MCPB
ITEM NO.
7-24-08

MEMORANDUM

PROJECT: Ridge Road at Snowden Farm Parkway Intersection Improvements

REVIEW TYPE: Water Quality Plan, and Mandatory Referral No. 08805-DPS-1

COVER SHEET.

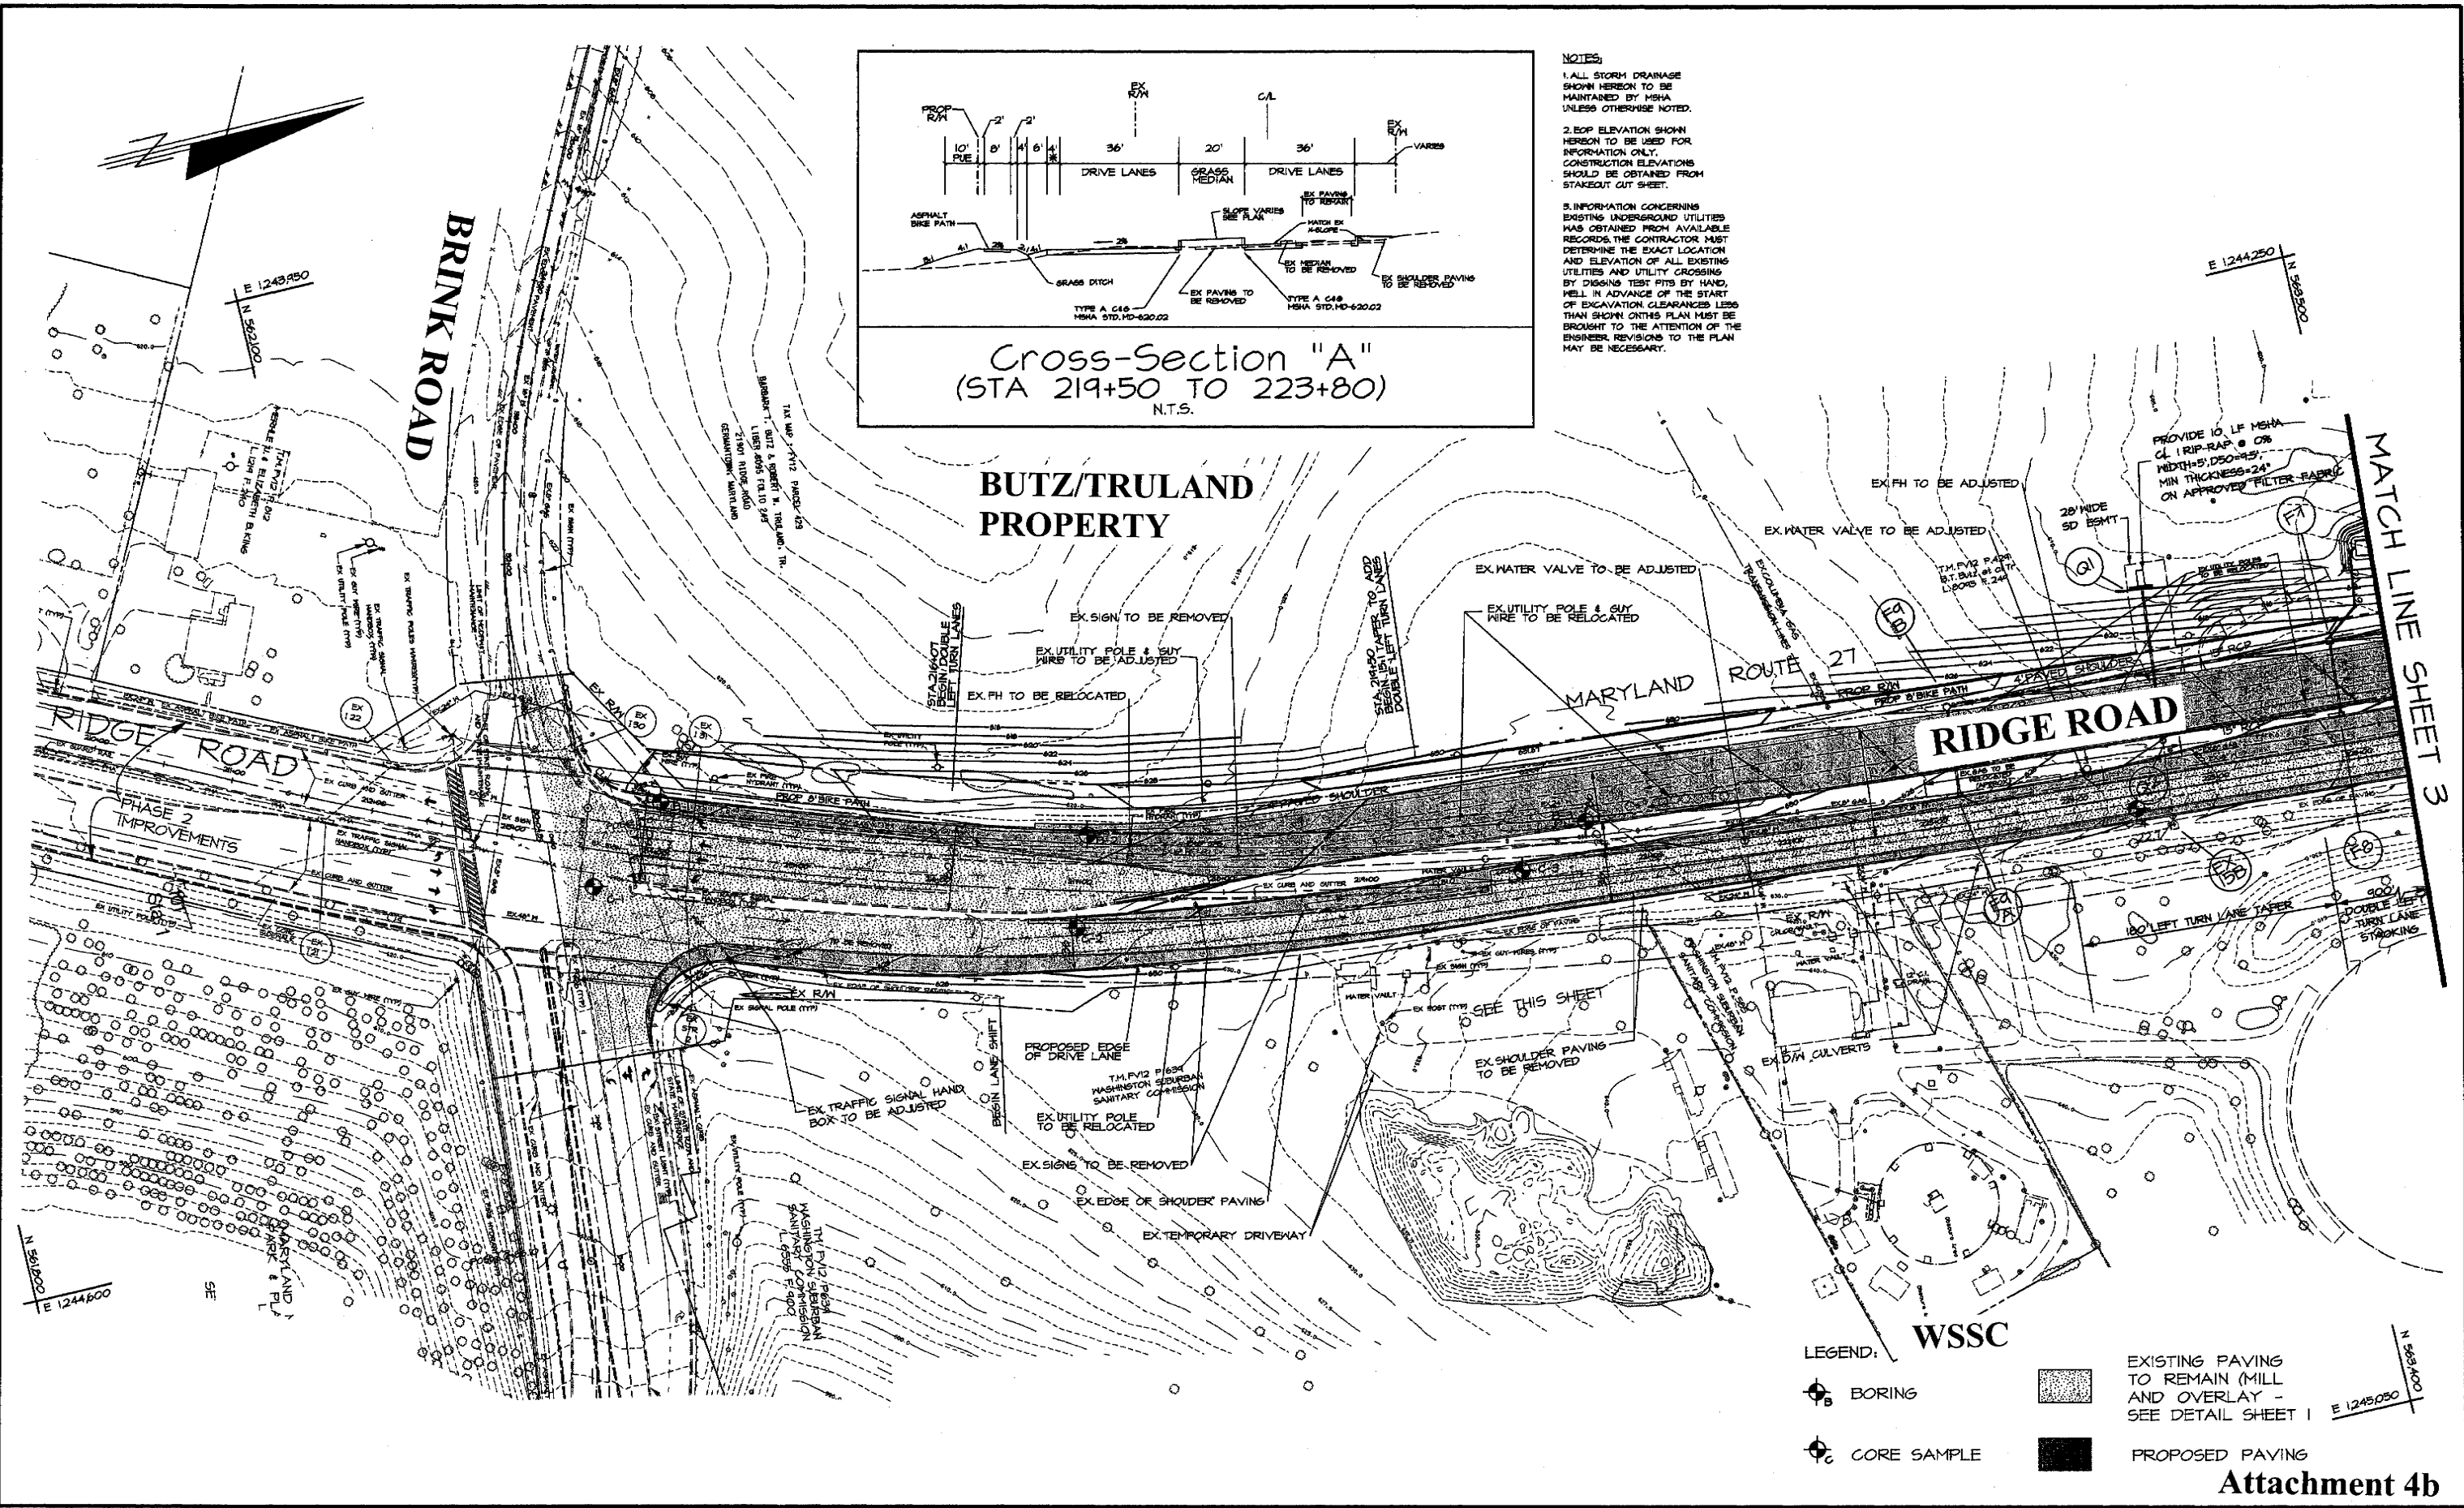
1. Narrow the travel lanes on Ridge Road to eleven feet and widen the southbound shoulder to six feet to improve on-road bicycle accommodation. Provide a marked bike lane connection for on-road bicyclists between the end of the proposed shoulder and Brink Road.

2. Widen the northbound roadway to 40 feet to provide a six-foot-wide bike lane to accommodate on-road bicyclists.
3. Provide dual, directional handicap ramps at the northeast and northwest corners of the Brink Road intersection and provide a median refuge on the north leg of Ridge Road at this intersection.

4. Provide dual, directional handicap ramps at the northwest and southwest corners of the Snowden Farm Parkway intersection and provide median refuges on the north and south legs of Ridge Road at this intersection.

5. Provide street trees - *Acer rubrum* 'Autumn Flame' 2-1/2"-3" cal., planted at fifty feet on center along Ridge Road.
6. Provide continuous street lighting along Ridge Road to AASHTO lighting standards by means of standard cobrahead fixtures with cutoff dark-sky-friendly luminaires.

We recommend that the travel lanes on Ridge Road be narrowed from 12 feet to 11 feet and that the proposed shoulders be widened to six feet to improve on-road bicycle accommodation.

While the proposed four-foot-wide shoulder on the southbound roadway would accommodate bicyclists, six-foot-wide bike lanes recommended by staff would provide better accommodation on a busy high-speed road. A restriping of the proposed pavement can accomplish this goal without affecting the overall pavement width. The proposed southbound shoulders end about 300 feet short of the Brink Road intersection. We recommend the on-road bike accommodation also be extended to the intersection by striping a bike lane immediately to the left of the right turn lane.

No northbound on-road bike accommodation is proposed and the proposed pavement width of 36 feet is insufficient to accommodate bicyclists, and is less than the County's current standard of 38 feet. Whereas the southbound roadway would be open-section (with a shoulder, but without curb and gutter), the northbound roadway is proposed to be curbed and the existing roadway shoulder removed, reducing rather than enhancing on-road bike accommodation. We recommend that the pavement width of the northbound roadway be widened to 40 feet to accommodate a six-foot-wide bike lane for on-road bicyclists. If a six-foot-wide bike lane is not provided, a waiver would be required from SHA.

Continuous roadway lighting is not proposed along Ridge Road but should be provided to AASHTO guidelines by means of standard cobrahead fixtures with cutoff dark-sky-friendly luminaires.

The proposed project would provide street trees along the west side of Ridge Road as well as in the twenty-foot-wide median. We recommend that the street trees should be *Acer rubrum* 'Autumn Flame' 2-1/2"-3" cal., planted at fifty feet on center per the Clarksburg Streetscape Plan.
